Models Affected: RZT 17 (17AA5A4G710, 712). RZT 42 (17AA5B4G709, 710), (17BA5A4G709, 710, 712)

Date: December 13, 2006 **Revised October 31, 2011 (Destroy All Previous Copies)**

Subject: **Service Replacement Hydro Transmissions 759-04142 & 759-04143.**

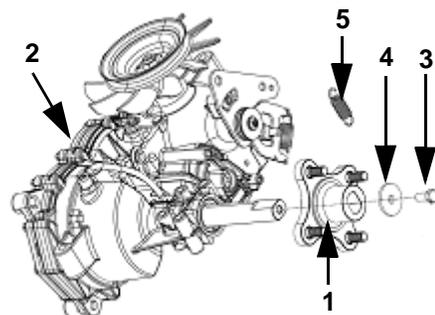
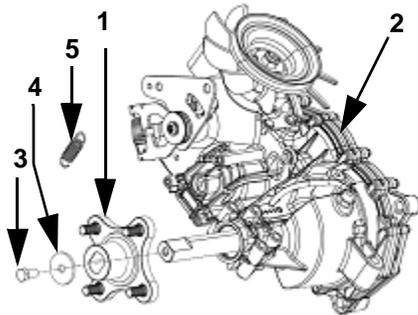
These Service Kits will replace the LH & RH hydro transmissions part numbers 618-04164, 618-04164A, 618-04327 & 618-04163, 618-04163A, 618-04326 when stock is depleted. The replacement transmission has a Double-D axle which requires a Double-D wheel hub assembly. The LH Transmission Service Kit 759-04142 & the RH Transmission Service Kit 759-04143 will include the items shown below.

ITEM NO.	PART NUMBER	QTY	DESCRIPTION
1	618-04494	1	HUB ASM: WHL:DOUBLE-D SHORT
2	618-04431B	1	TRANS ASM: HYDRO:EZT:LH
3	710-3119	1	SCREW:3/8"-16 x .750:GR5:LOCK
4	736-0227	1	WASHER:FLAT: .390 x 1.50 x .134
5	732-04448	1	SPRING: EXTENSION (See Page 2)

ITEM NO.	PART NUMBER	QTY	DESCRIPTION
1	618-04494	1	HUB ASM: WHL:DOUBLE-D SHORT
2	618-04432B	1	TRANS ASM: HYDRO:EZT:RH
3	710-3119	1	SCREW:3/8"-16 x .750:GR5:LOCK
4	736-0227	1	WASHER:FLAT: .390 x 1.50 x .134
5	732-04448	1	SPRING: EXTENSION (See Page 2)
